ERRATA SHEET

PRODUCT FAMILY: DURAPULSE GS3 AC Drives

USER MANUAL NUMBER: GS3-M

ERRATA SHEET NUMBER: GS3-M Errata #5

CLICK C0-02: RS-485 CONNECTION WIRING

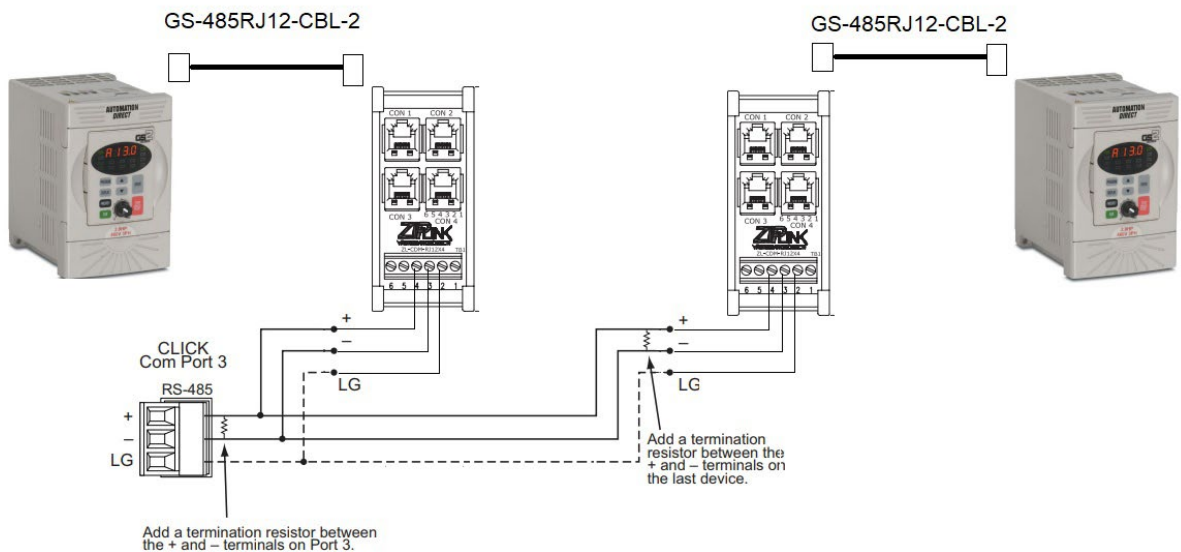
Chapter 5, pg 5-15:

Add CLICK PLC Communication Diagram as Shown:
